SUBJECT: AMENDMENT 54 - HOUSEKEEPING ITEMS (LICENSE CONDITION 11)

TECHNICAL EVALUATION REPORT

DOCKET NO. 40-6659 LICENSE NO. SUA-551

FACILITY: Shirley Basin, Wyoming

Figure 5.1-1

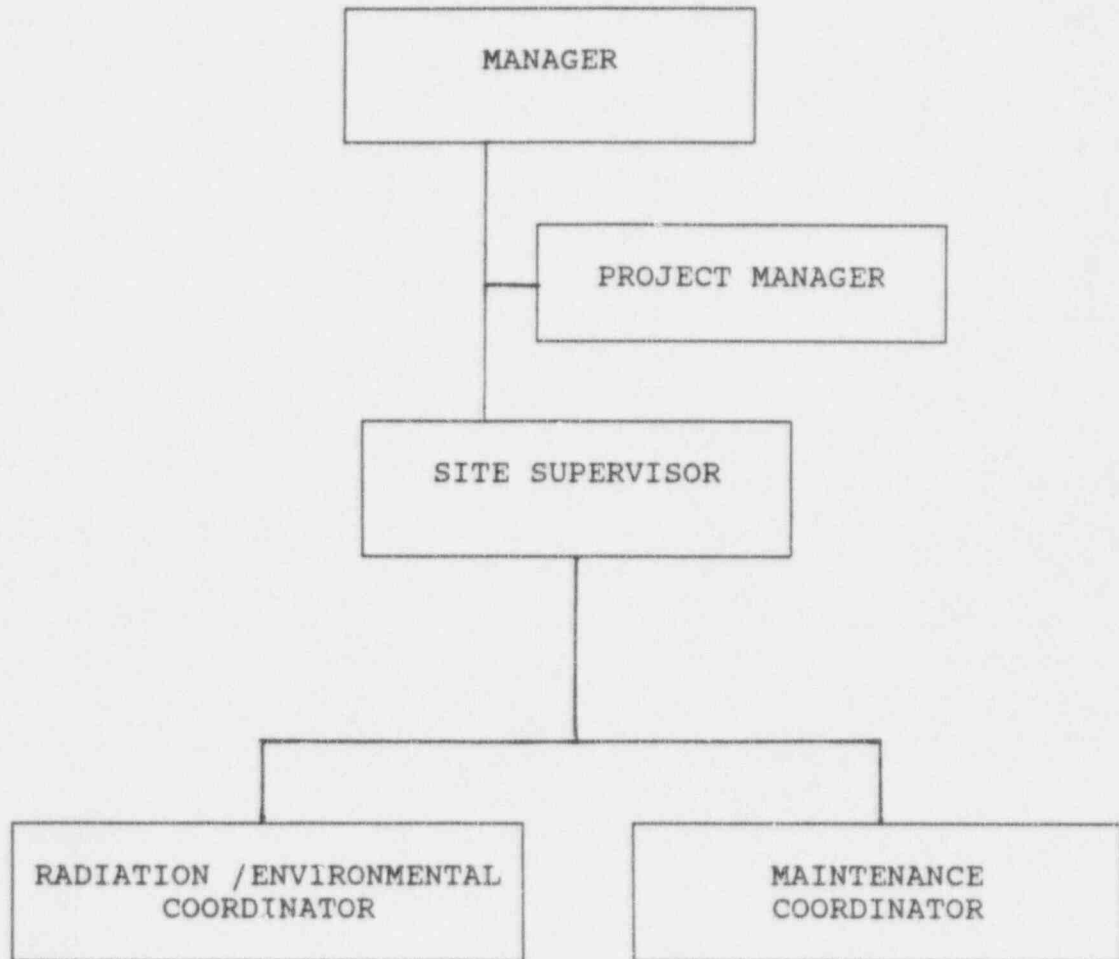
Figure 5.1-1 (Organizational Chart). Modify to reflect current status.
